Docket No. 50-219

FACILITY: Oyster Creek Nuclear Generating Station

SUBJECT: MEETING FEBRUARY 13, 1985, ON INSTALLATION OF QUALIFIED
CONTAINMENT PURGE AND VENT VALVES DURING CYCLE 11R OUTAGE

FIGURE 8.3-38

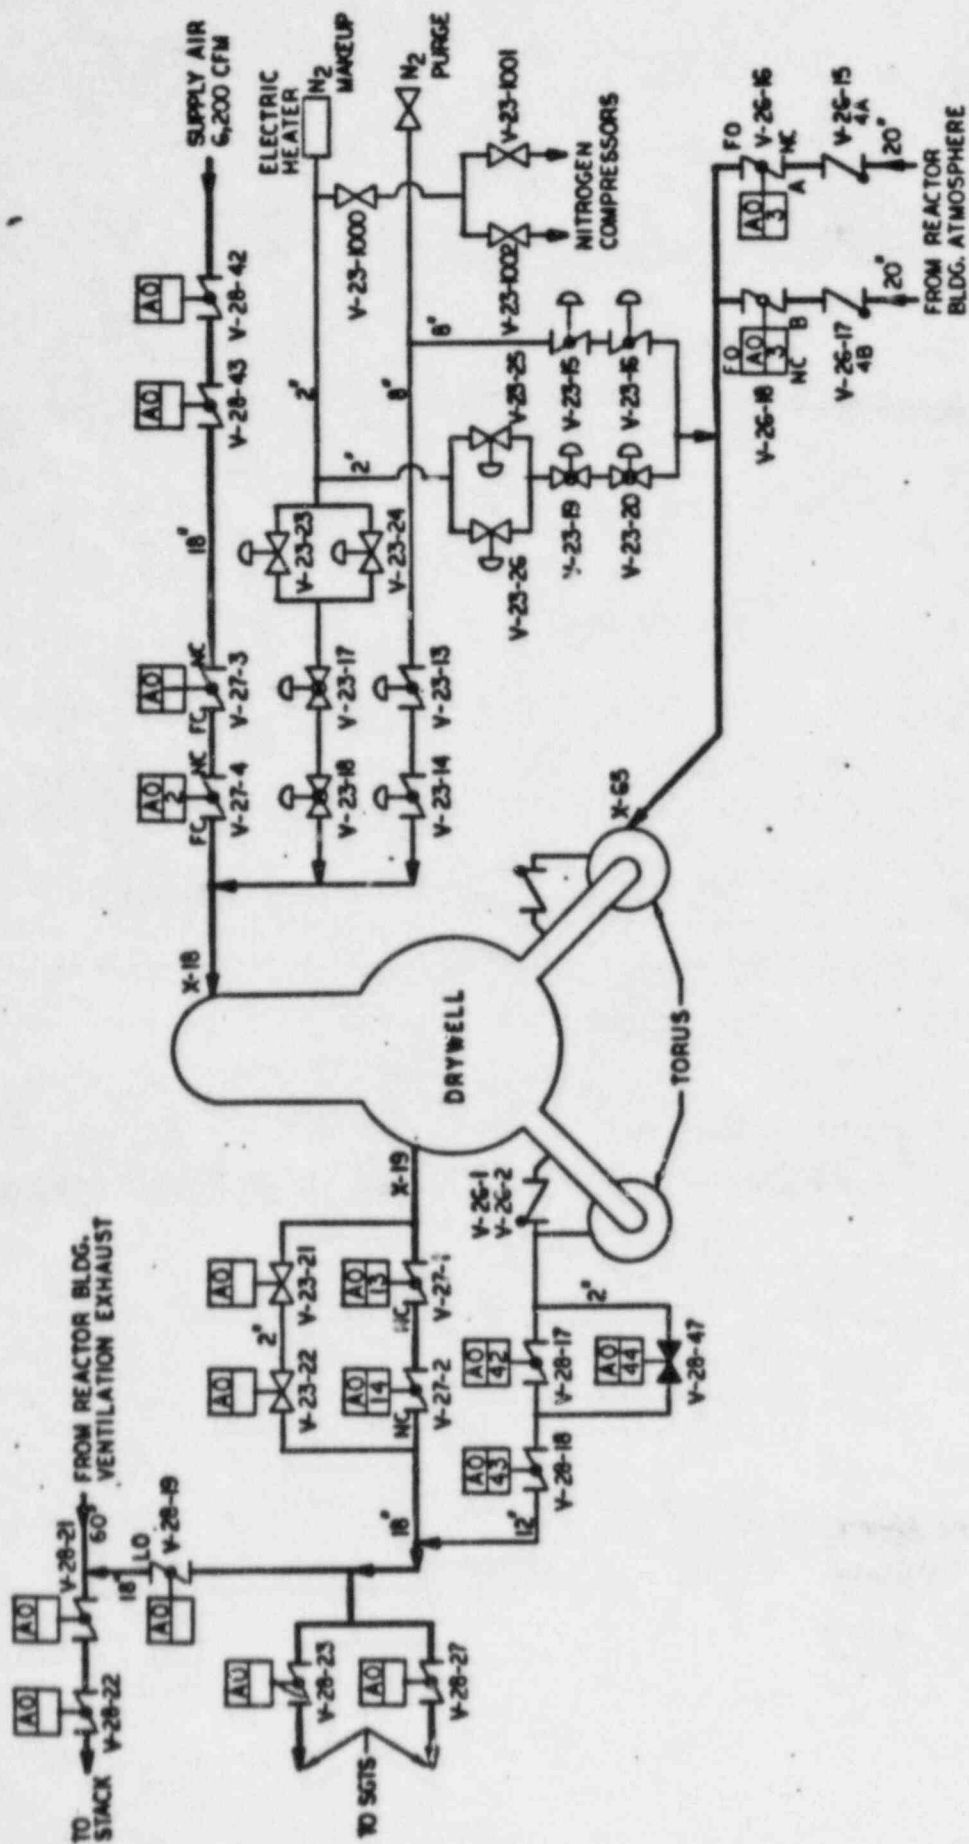
The licensee stated that the request to not replace the containment purge and vent isolation valves by qualified valves will affect valves V-27-1/2, V-28-17/18/47, V-27-3/4, V-23-13/14 and V-23-15/16 in the figure in Attachment 2. All these are containment isolation valves. The request to not upgrade the nitrogen system will affect valves V-23-17/18, V-23-19/20, V-23-21/22 and V-28-47 of this figure.

The licensee stated that the commitment on the containment isolation valves is being considered to be withdrawn because these valves are blocked partially closed and met the staff's interim position for containment purge of October 23, 1979. The licensee would propose this interim position as its final position. The licensee stated that this position is conservative and the valves will close against the design basis accidents.

The licensee stated that considerations to propose the withdrawal of the commitment on the nitrogen system was based on the BWR Owner's Group model of the hydrogen source term for the LOCA. This model was an analysis performed by General Electric (NEDO-22155). The licensee stated the BWROG's model showed Oyster Creek should not reach the hydrogen flammability limit within 2 years after the LOCA.

The staff and the licensee discussed the technical arguments for the licensee's proposed withdrawal of its commitments. The staff stated that the licensee should propose additional technical specifications on the existing containment vent and purge isolation valves to inspect and test these valves if they have resilient seals. The valves that would replace the existing valves do not have resilient seals. The staff referred to its January 18, 1985, letter to the BWROG which stated that a containment high range radiation signal should go to all containment vent and purge isolation valves, large and small. The staff stated that 10 CFR Part 50.44(d) provides a design basis hydrogen source and that Generic Letter 84-09 (May 8, 1984) provides a basis for an exemption to the recombiner capability required in 10 CFR Part 50.44(c)(3)(ii) but it is not applicable for design basis accidents.
